ENGINEERING REPORT

61 BUTLER RD, BOULDERCOMBE Q

Contract No. CE18014 - 1 into 4 Lot Subdivision – Engineering Report

Development Permit No.: D/20-2018

PLAN LAYOUT
SCALE 1:5000

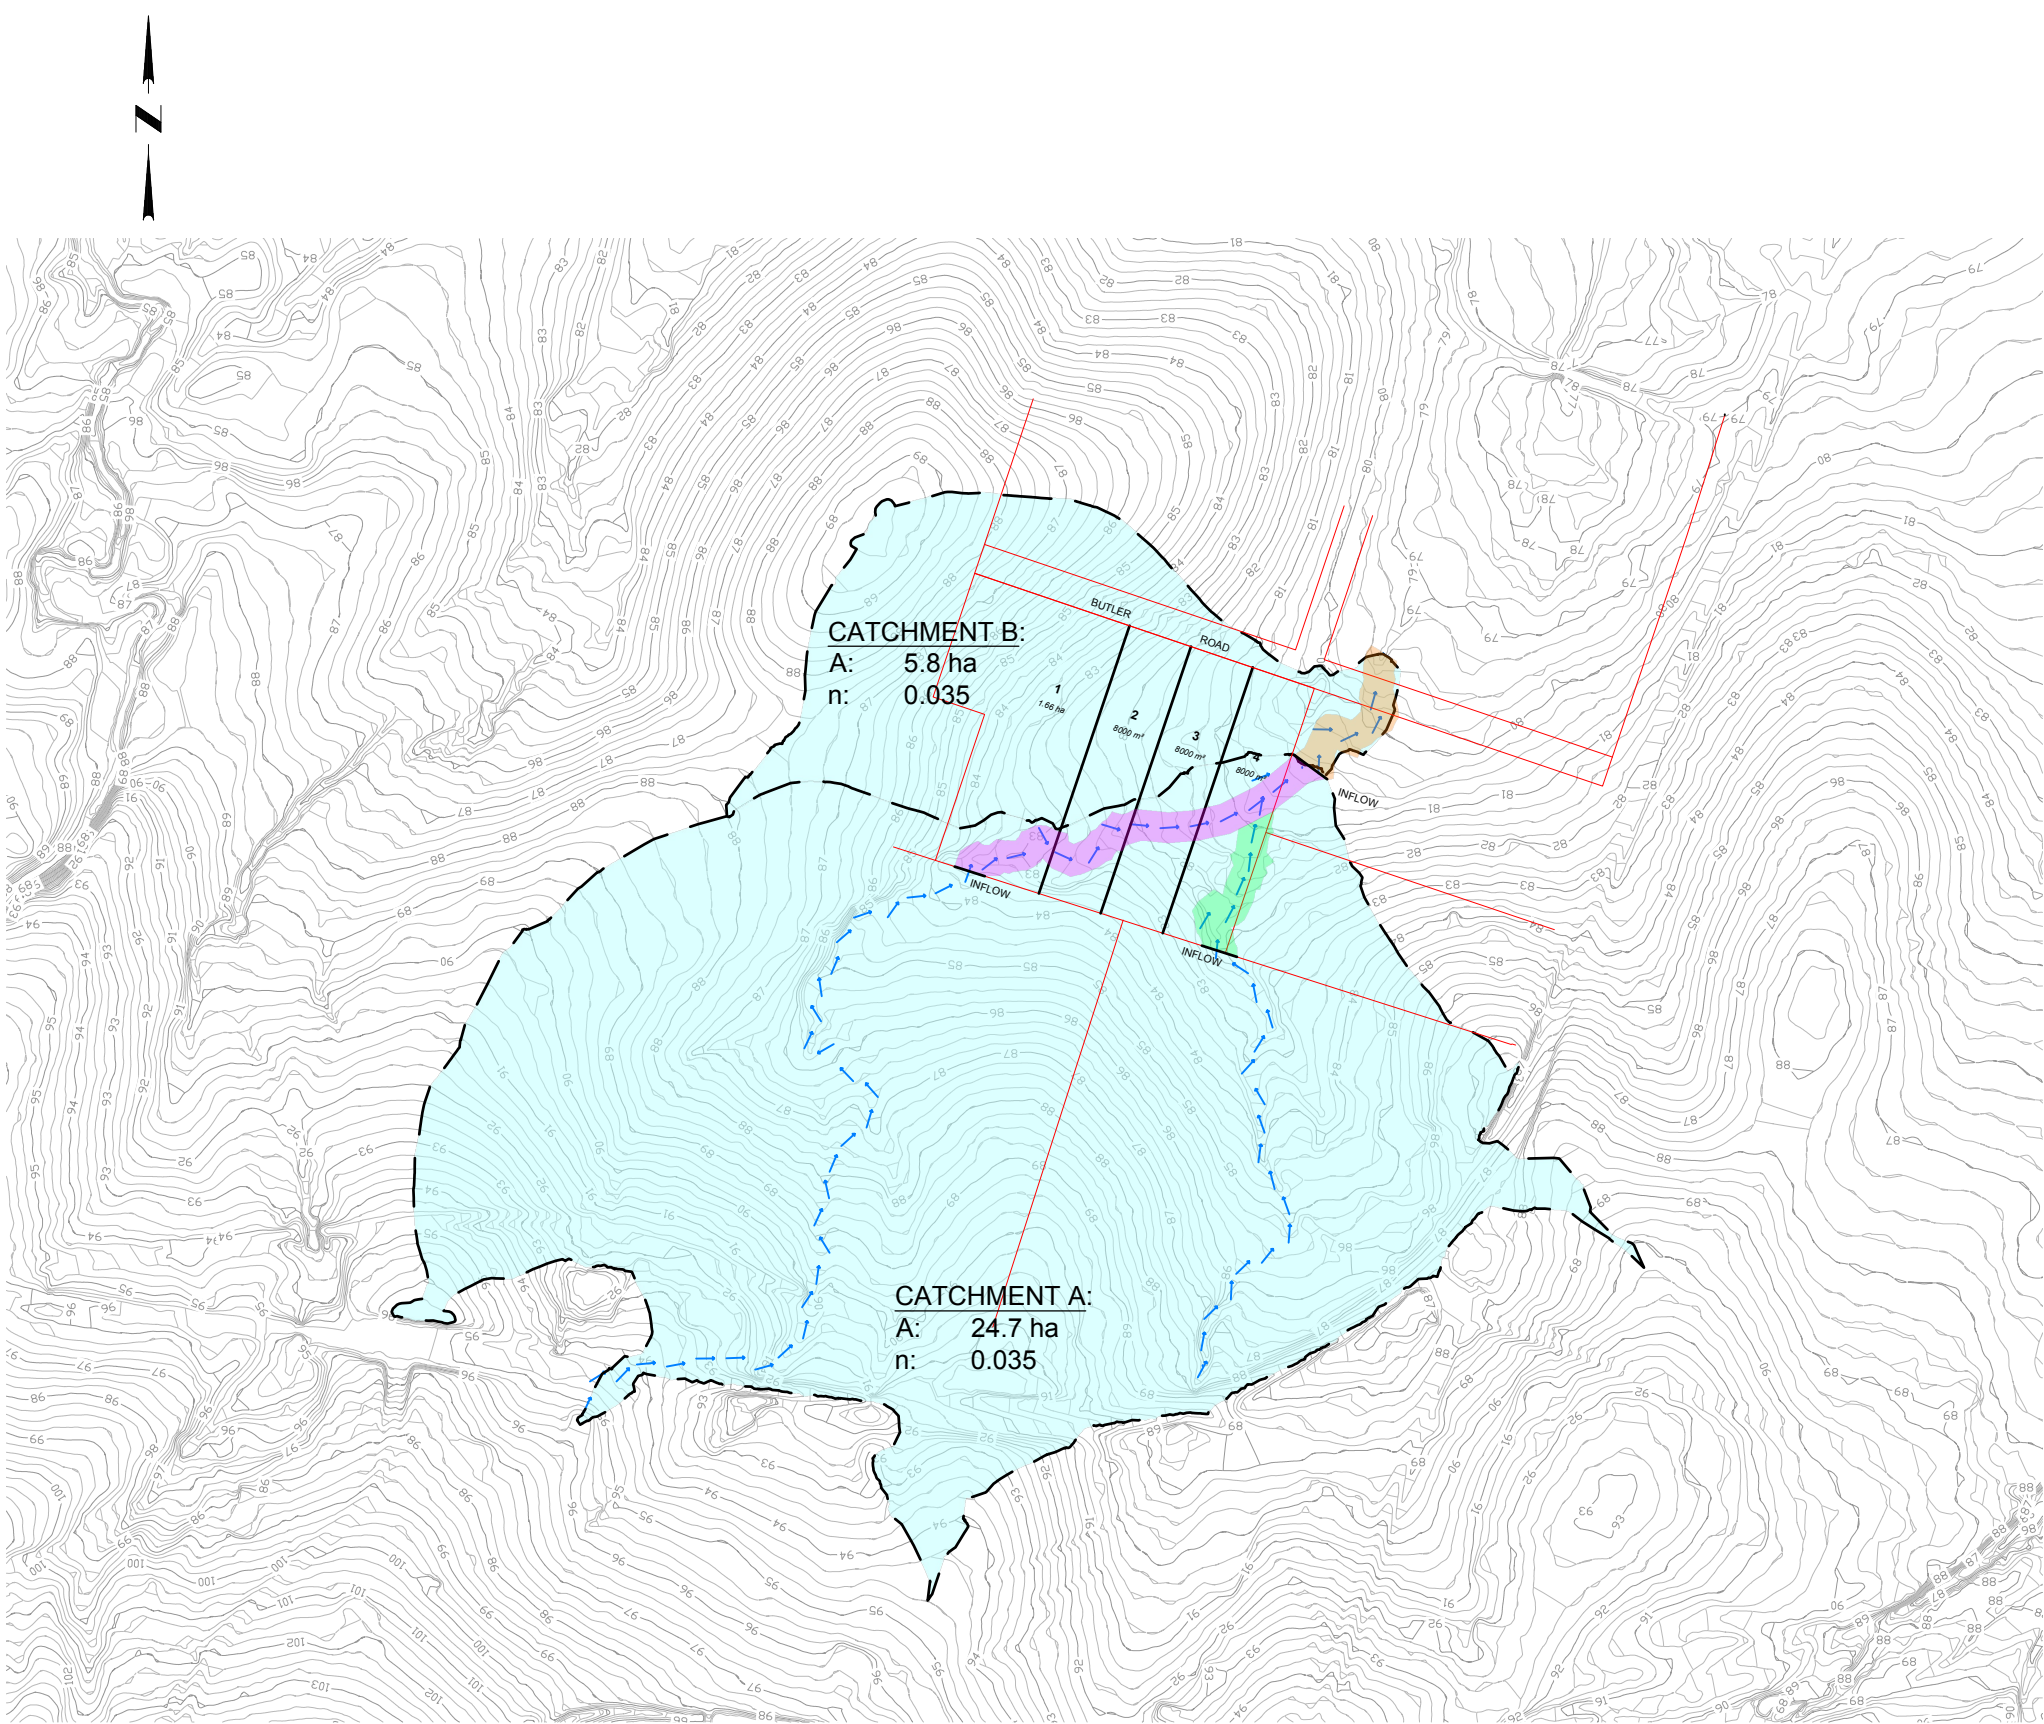
- 1.1. Please Provide an overland flow path assessment report for the subject land prepared and certified by a Registered Professional Engineer of Queensland that as a minimum includes:
 - 1.1.1. Identification of catchments of these flow paths;
 - 1.1.2. An assessment of the peak discharge of a one percent (1%) Annual Exceedance Probability defined flood event;
 - 1.1.3. Identification of all areas of the subject land to be provided as dedications/easements in favour of Council for the purpose of conveyance of the one percent (1%) Annual Exceedance Probability defined flood event. These dedication/easement areas as must be detailed on a suitably scaled and adequately dimensioned conceptual layout plan; and
 - 1.1.4. Details of all calculations, assumptions and data files (where applicable).

For establishing the estimated generated stormwater run-off for fully developed scenario of Catchment A, the time of concentration in accordance with QUDM's Section 4.1 for Rural Catchments, adopting Bransby-Williams formula was calculated to be 67 minutes.

In accordance with Tables 4.5.1 to 4.5.4 of QUDM, the existing runoff coefficient (C_{10}) of 0.59. Based upon the above calculations, the following flow rates generated by the upstream catchment were as follows:

- » Minor Storm Event (2 year ARI) 1.46 m³/sec, &
- » Major Storm Event (100 year ARI) 4.90 m³/sec.

The discharges presented in the above Section 1.4.1 were input into the model, with Manning's values used throughout the model are presented in APPENDIX C. The existing inundation plots show the 100yr & 2yr ARI events, presented further in APPENDIX A (Plans CE18014-002 & CE18014-003).

PLAN LAYOUT
SCALE 1:2000

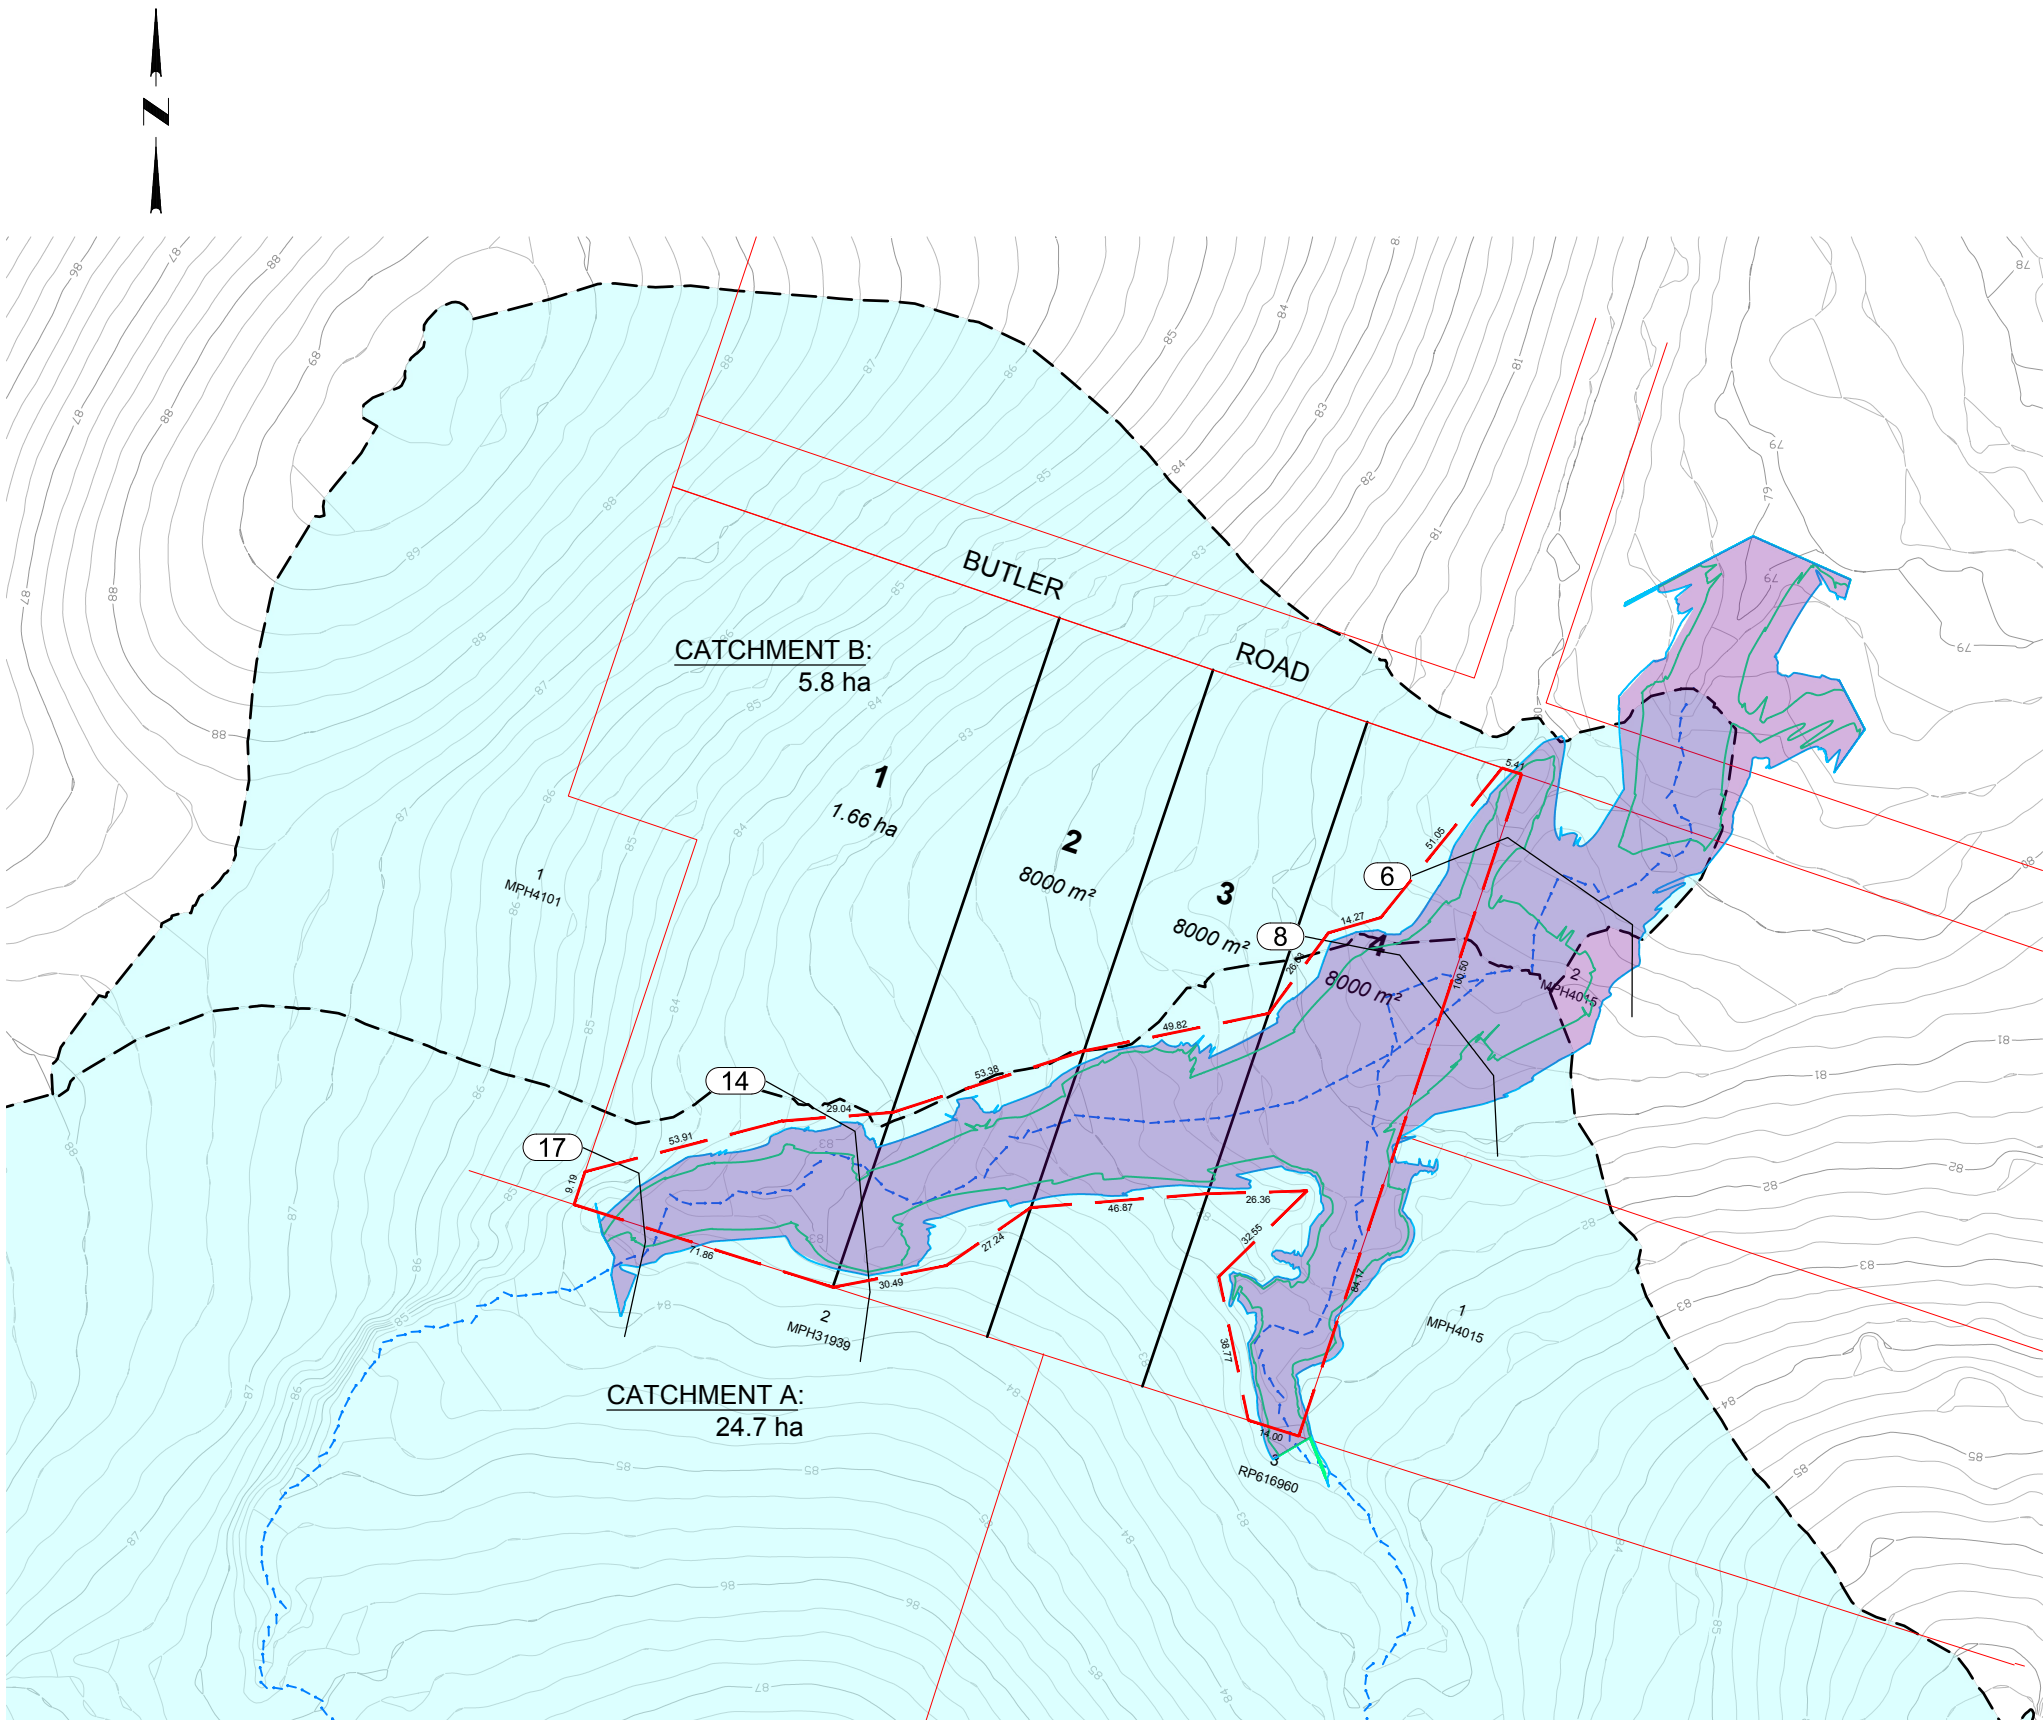
As per Item 1.1.3 of the RFI by RRC, the proposed 1 into 4 Lot subdivision will require that there be a dedicated easement drawn to encompass the full extent of the 1% ARI event.

It has been adopted at the request of the property owner, that the dedicated easement in favour of RRC be drawn over the existing 1% ARI flood event extent demonstrated on drawing CE18014-003. Therefore, from this impact plot it can be confirmed that the shallow 1% ARI flood event can be conveyed within the easement defined in APPENDIX D (18072-PP-01 Rev B by Vision Surveys), as per Item 1.1 of the RRC RFI.

By incorporating the recommendations of this report into the proposed design, Moloney & Sons can confirm the 1% ARI storm event will be completely incorporated within the proposed drainage easement, safeguarding against any potential actionable damage and/or adverse effect caused to effected properties by the proposed subdivision.
